ROOSEVELT ELEMENTARY SCHOOL MODERNIZATION

2324 VERDE STREET
FOR
BAKERSFIELD CITY SCHOOL DISTRICT
BAKERSFIELD, KERN COUNTY, CALIFORNIA

TITLE SHEET, SHEET INDEX & VICINITY MAP

FLOOR PLAN
BUILDING 'C',
PARTIAL FLOOR
PLAN & DEMO
FLOOR PLAN

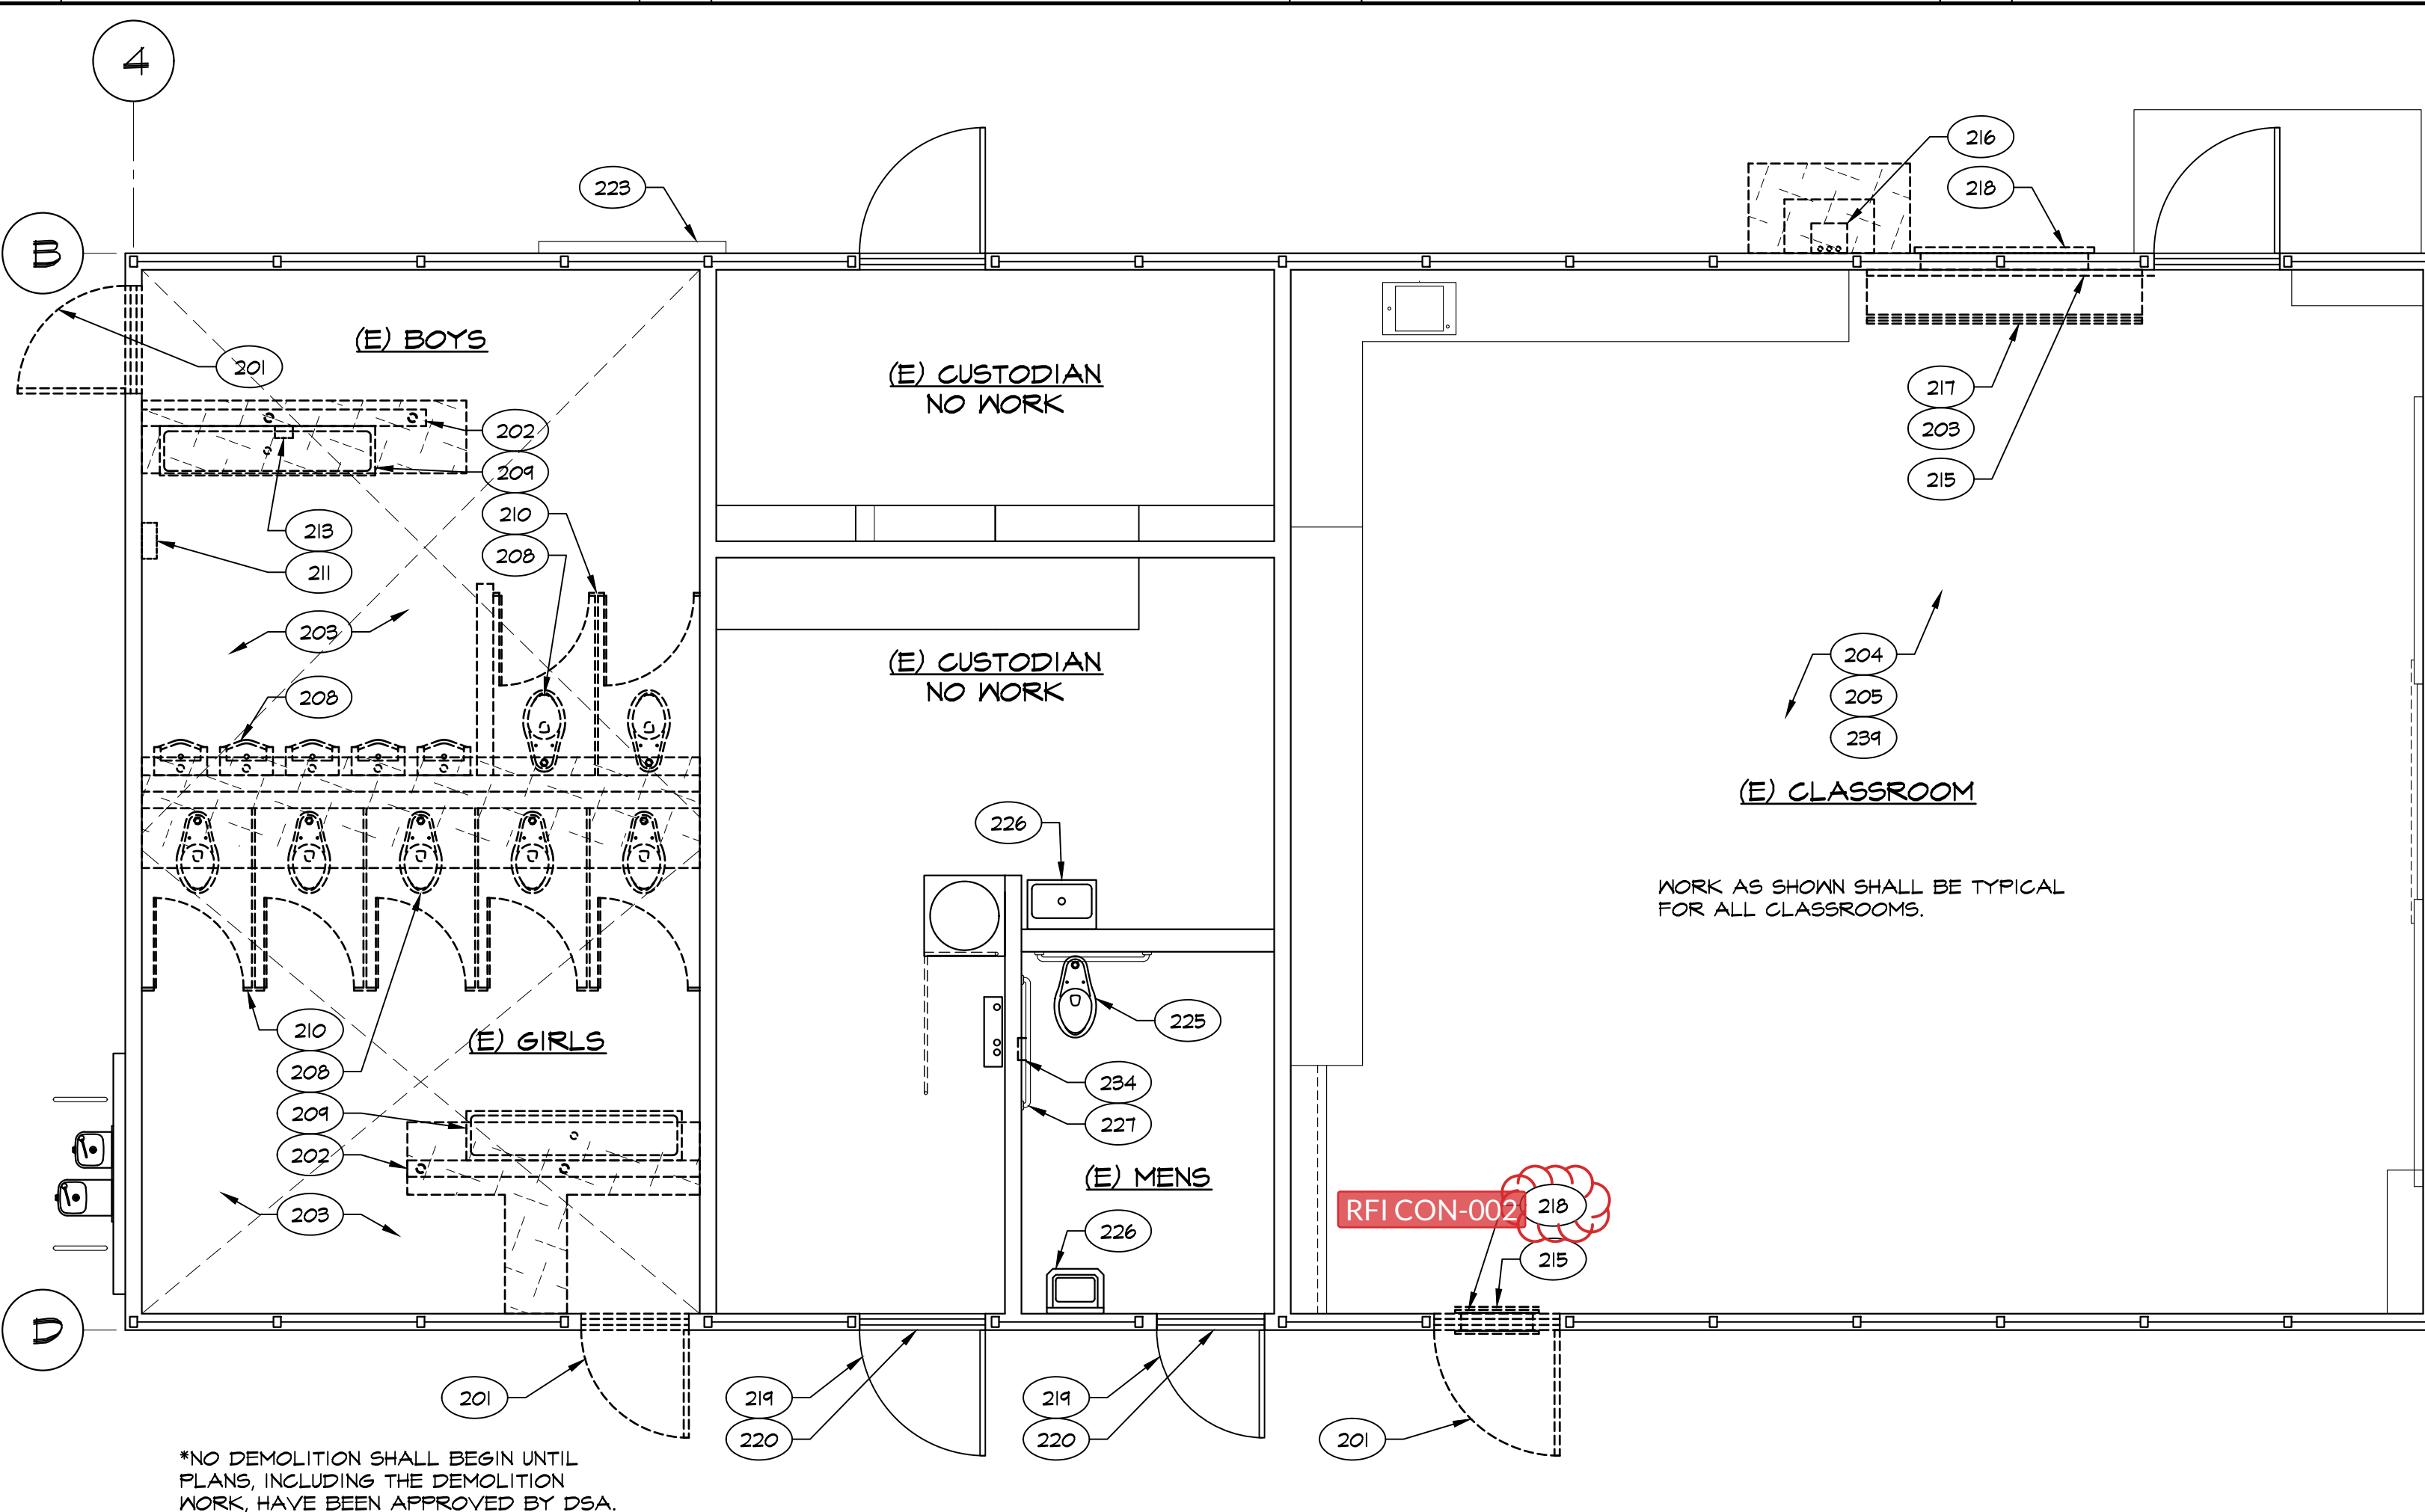
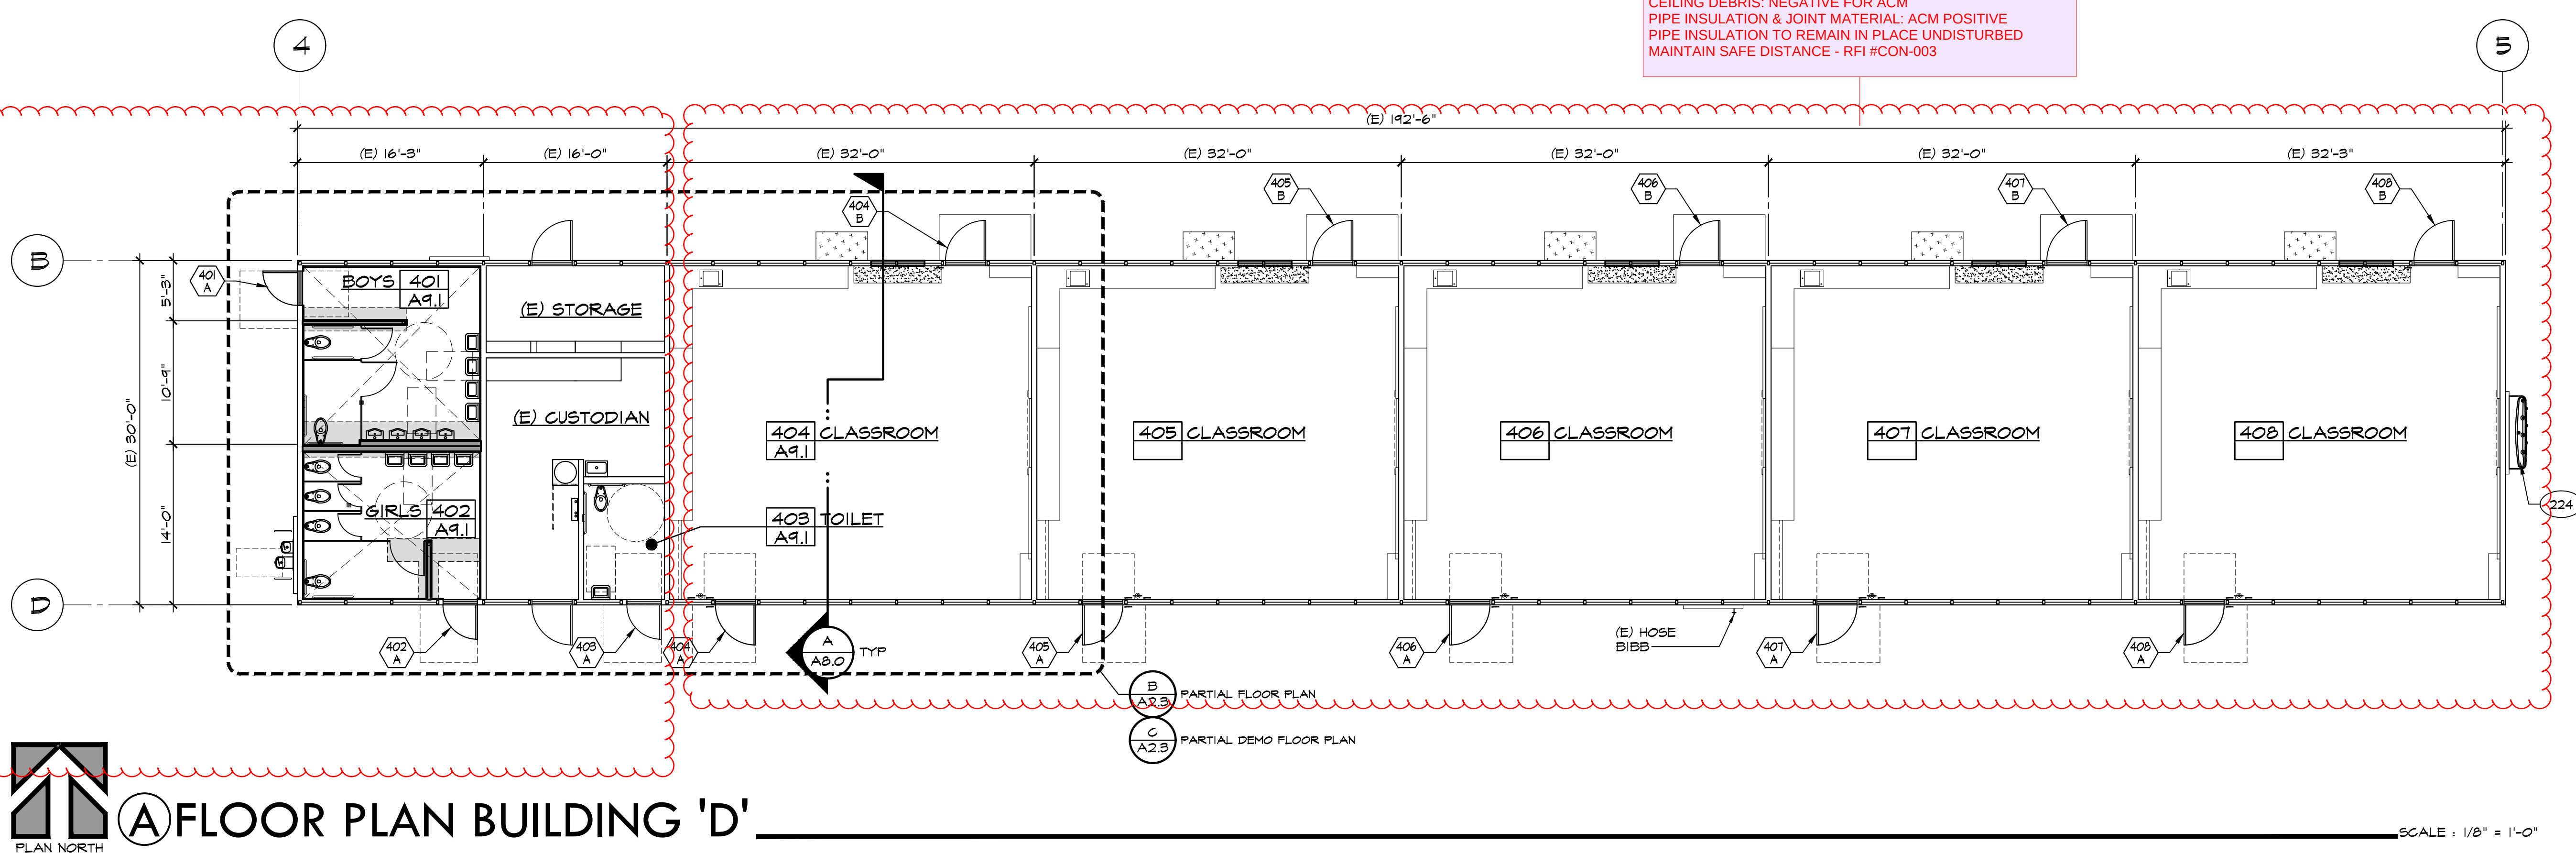
CON-039 | Sheets: A2.3
DEPRESSED SLAB CLARIFICATION
RESTROOMS 401 & 402
PER RFI-039 (07/08/25)

RFI CON-003 — ACM Pipe Insulation
CEILING DEBRIS: NEGATIVE FOR ACM
PIPE INSULATION & JOINT MATERIAL: ACM POSITIVE
PIPE INSULATION TO REMAIN IN PLACE UNDISTURBED
MAINTAIN SAFE DISTANCE - RFI #CON-003

FLOOR PLAN
BUILDING 'E'
& DEMO
FLOOR PLAN
BUILDING 'E'

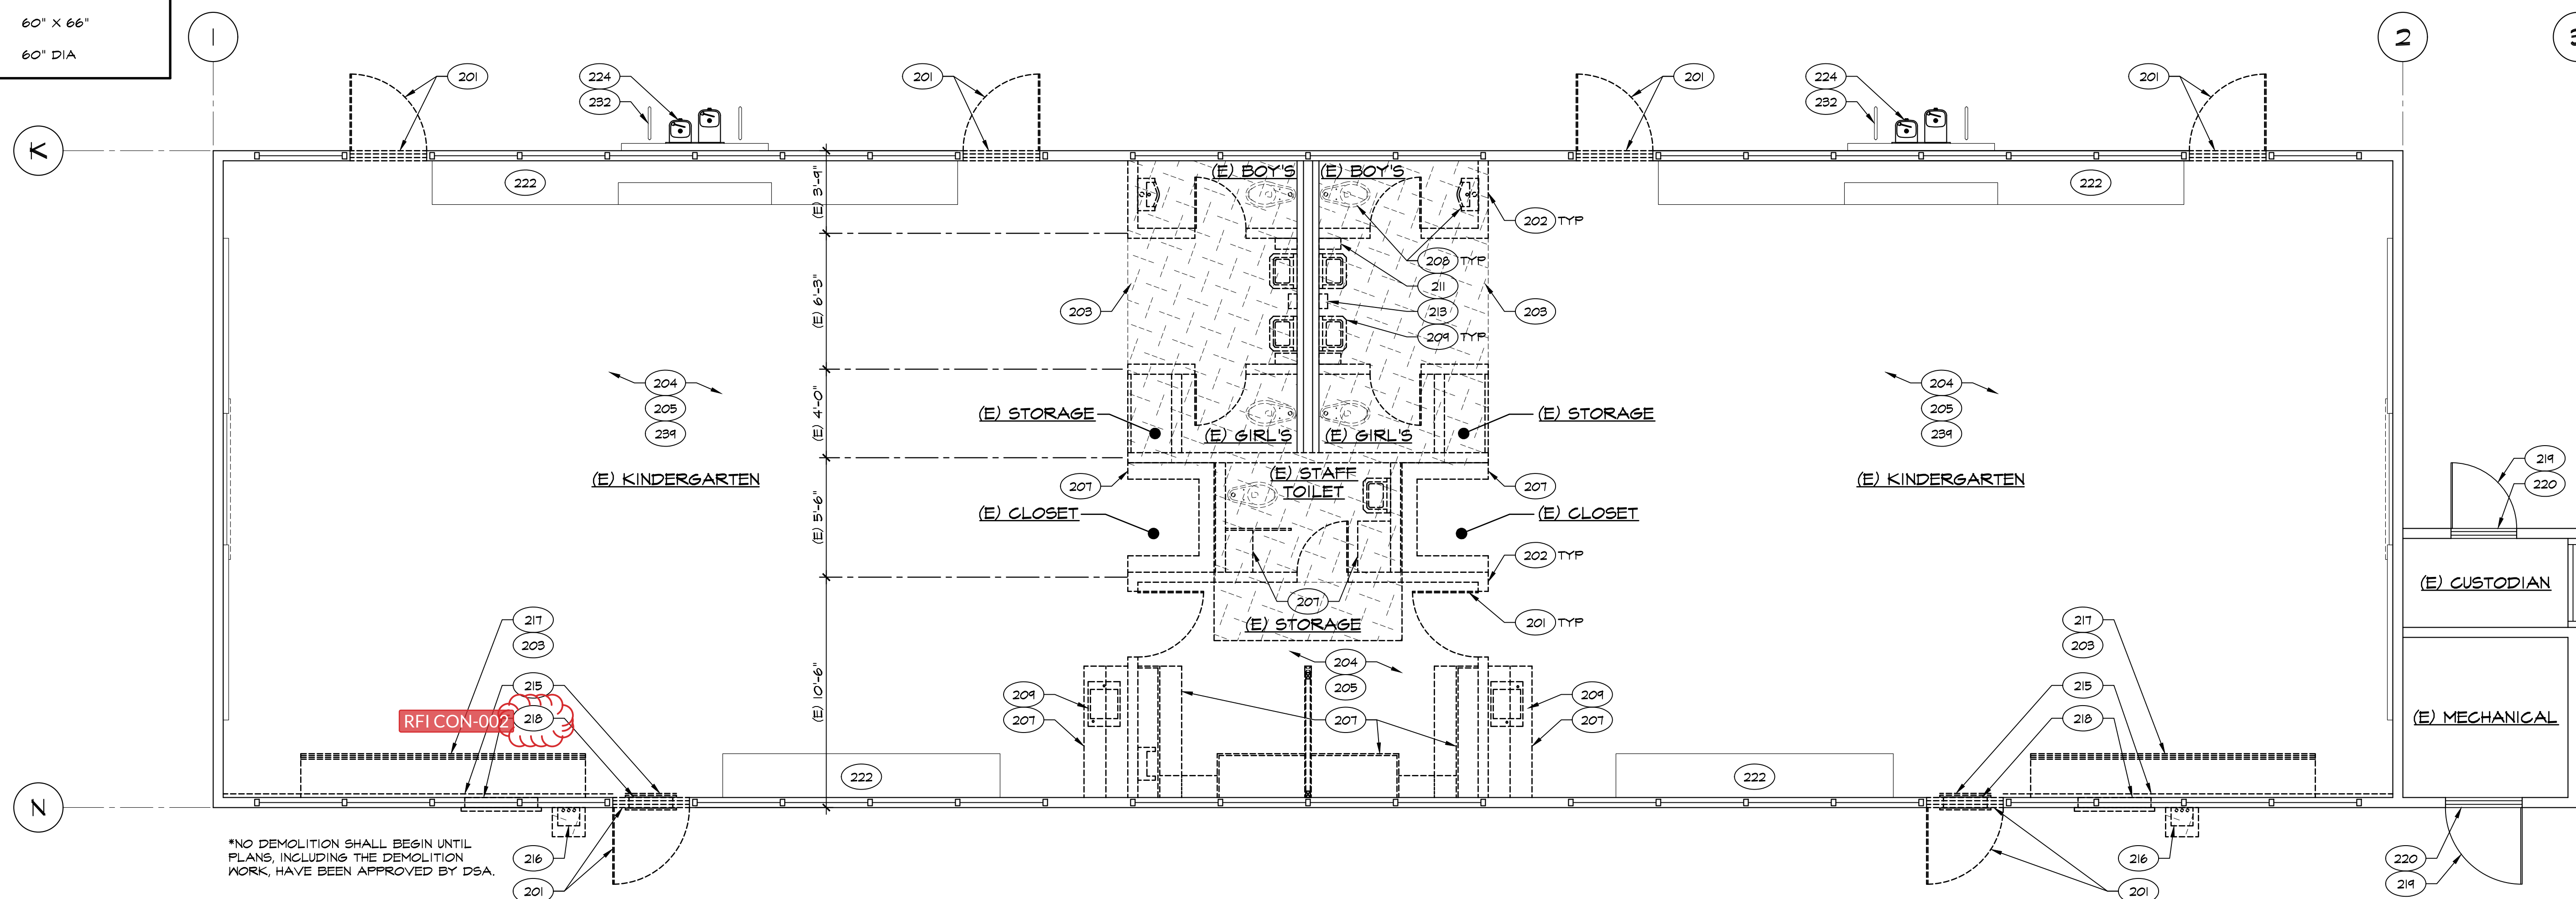
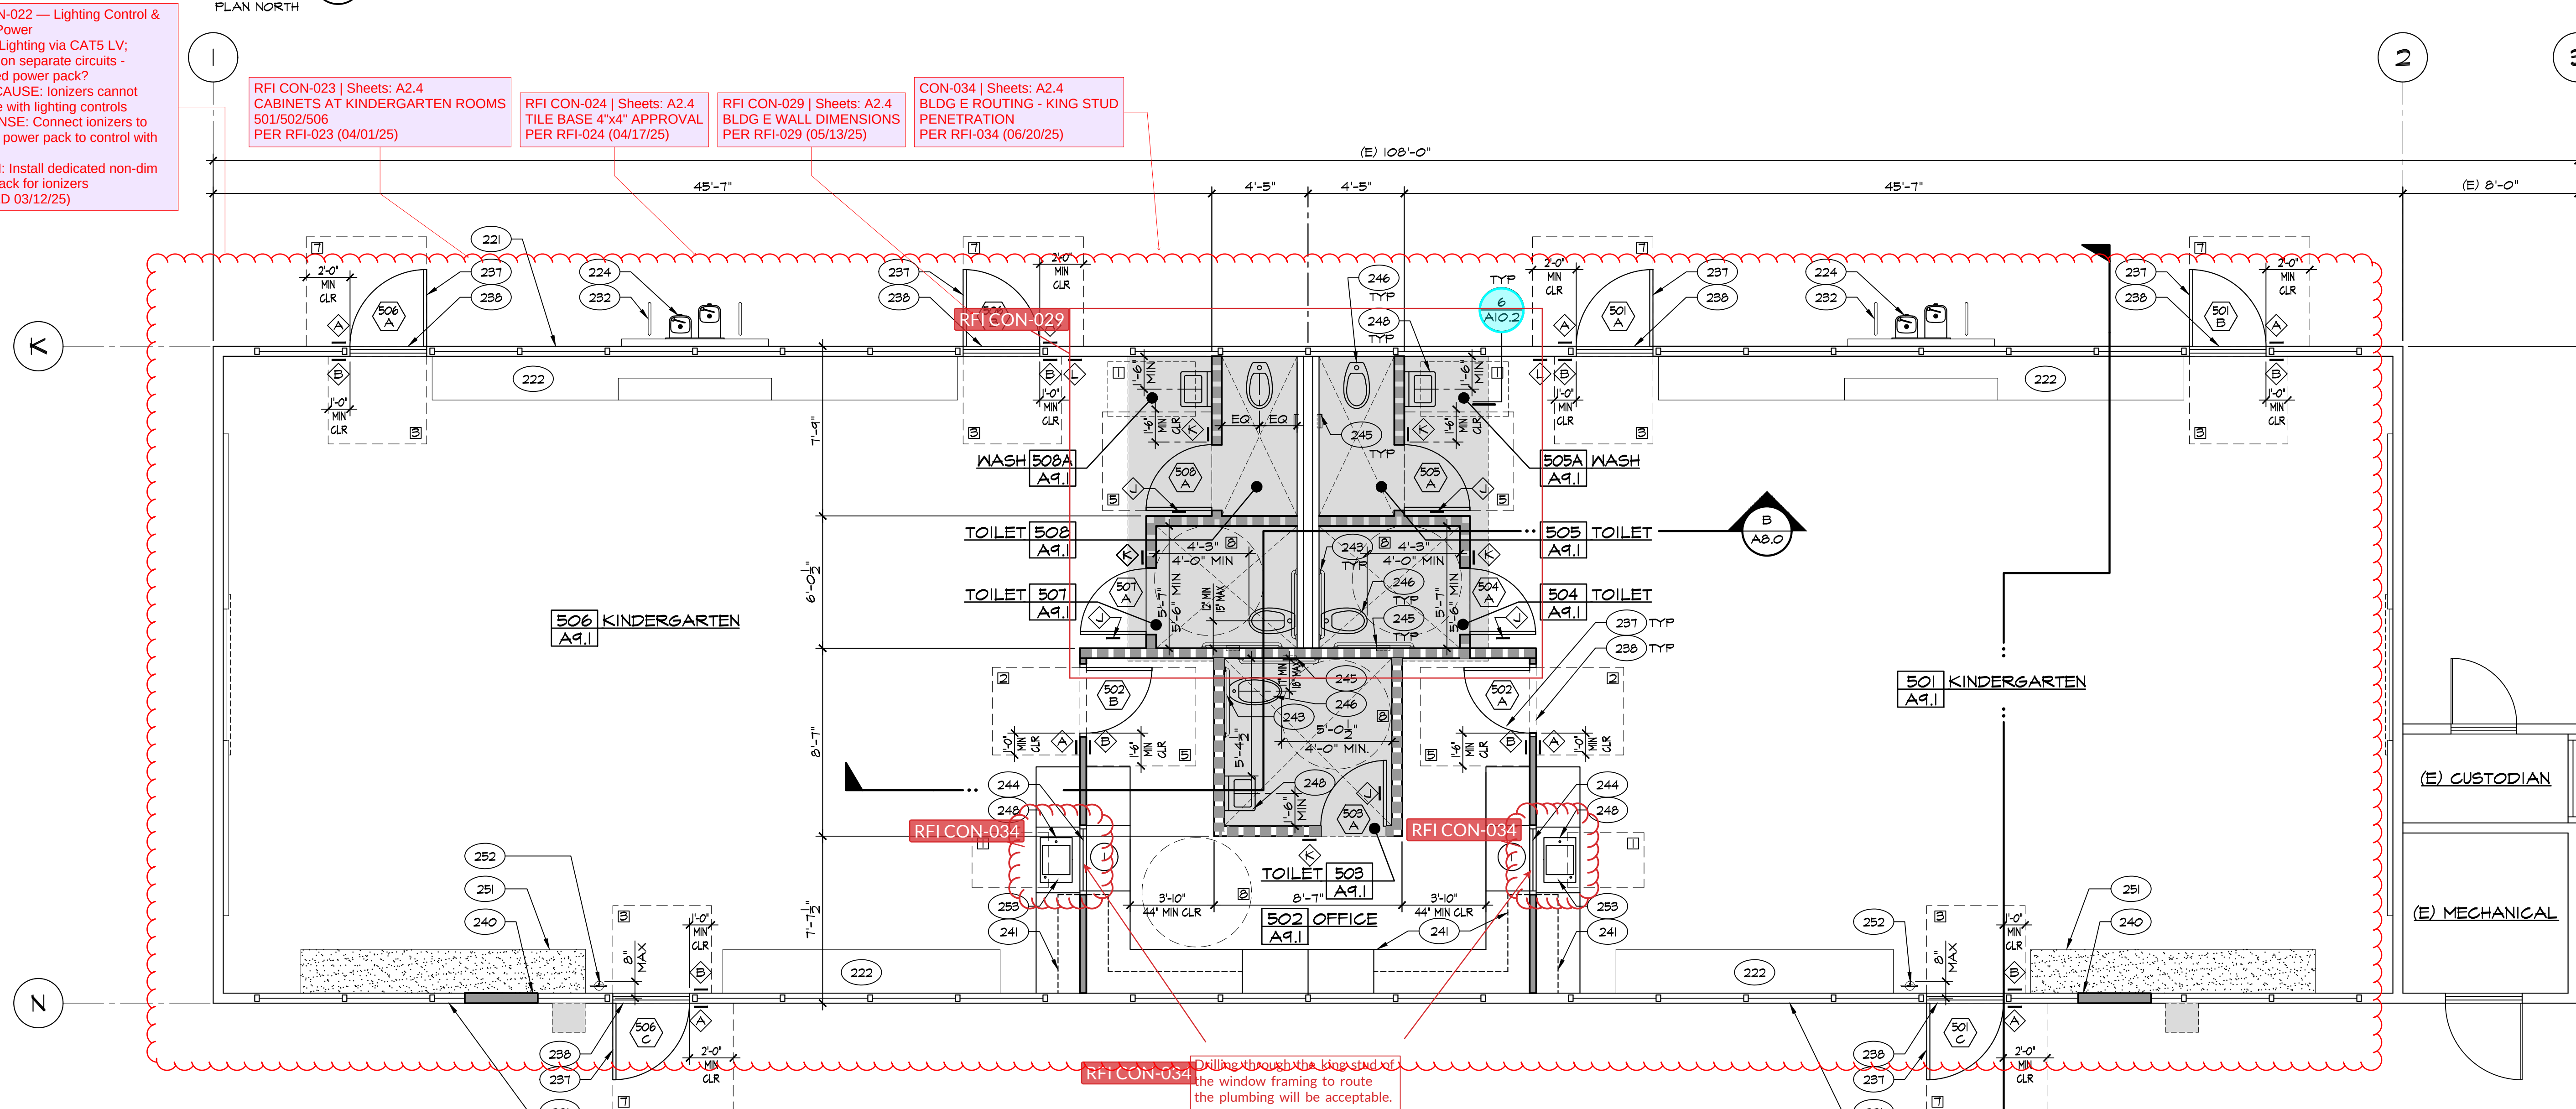
RFI CON-022 — Lighting Control & Ionizer Power
ISSUE: Lighting via CAT5 LV; ionizers on separate circuits - dedicated power pack?
ROOT CAUSE: Ionizers cannot integrate with lighting controls
RESPONSE: Connect ionizers to non-dim power pack to control with lighting
ACTION: Install dedicated non-dim power pack for ionizers (CLOSED 03/12/25)

RFI CON-023 | Sheets: A2.4
CABINETS AT KINDERGARTEN ROOMS
501/502/506
PER RFI-023 (04/01/25)

RFI CON-024 | Sheets: A2.4
TILE BASE 4"x4" APPROVAL
PER RFI-024 (04/17/25)

RFI CON-029 | Sheets: A2.4
BLDG E WALL DIMENSIONS
PER RFI-029 (05/13/25)

CON-034 | Sheets: A2.4
BLDG E ROUTING - KING STUD
PENETRATION
PER RFI-034 (06/20/25)
